Flight Procedures Cover Page	Task Action: FLIGHT CHECK	Task Type: IAP	Estimated Chart Date: 05/14/2026	APWS Task ID: 340CEB88DFEC4064A498CEDF3A4C2FBE	APWS Project ID: 058F73A8FF1A44249DE407BF8689137D
Procedure: ILS OR LOC RWY 27 AMDT 12		Enroute: NO	Specialist: Johnsen, Daniel		Agreement Number:
Airport ID: KDLH			Airport City: DULUTH		State: MN
Facility ID: JUD	Facility Type: ILS	Flight Inspection Remark Type: New FC Slot

PROCEDURE: ILS OR LOC RWY 27 AMDT 12		AIRPORT NAME: DULUTH INTL		AIRPORT ID: KDLH	SPECIAL CONTROL NO: BP-02-050-26
FAC ID: JUD		CITY: DULUTH		ST: MN	ORIG CHART DATE: 05/14/2026
DFL TYPE: PROC/A	THIRD PARTY: <input type="checkbox"/> YES	EST. TIME ON SITE: 0.4	REIMB. NUMBER:	PTS TASK ID: 340CEB88DFEC4064A498CEDF3A4C2FBE

ILS or LOC RWY 27

DULUTH INTL (DLH)

ILS or LOC RWY 27

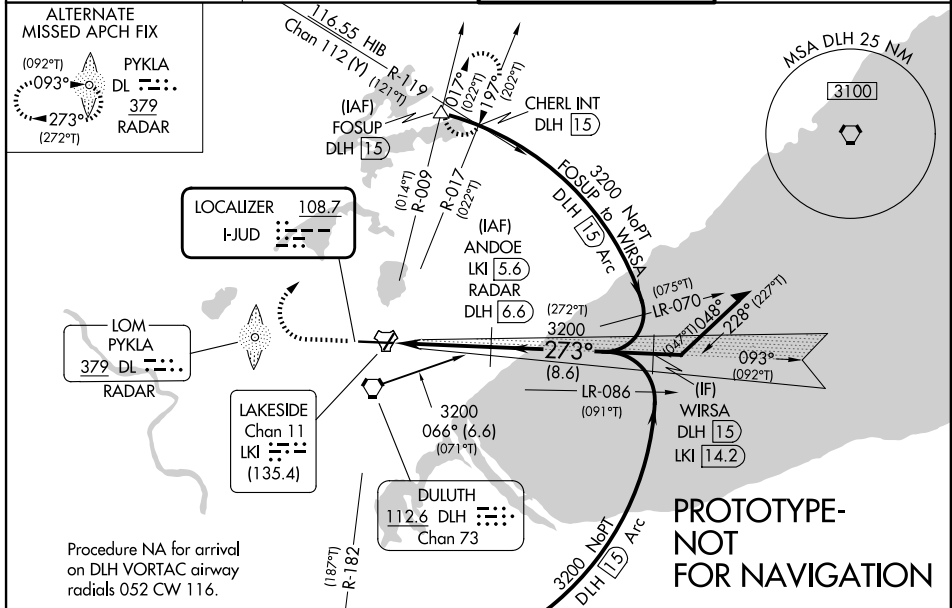
2. VDP definition for VDP 1.19 from threshold (8260-3, pg 2 of 3) needs to specify LKI DME. FIG says I-JUD DME, which does not exist.
 3. PYKLA LOM 8260-2 (Rev 15) has 2 different "actual facility location lat/long" in remarks

4. LKI TACAN DME will be of limited use. Paired frequency 135.4 cannot be tuned into standard VOR/ILS receivers. For instance, our Pro-Line 21 avionics can only tune in 108.0 to 117.95 MHz. It would require a special add-on modification in order to tune in other frequencies (133.0 to 135.95), which we do not have. LKI DME is accurate, we have a TACAN receiver (for flight check planes), but it will be of no use to most users. LKI DME is not required for the approach, and performed SAT. But near zero utility.
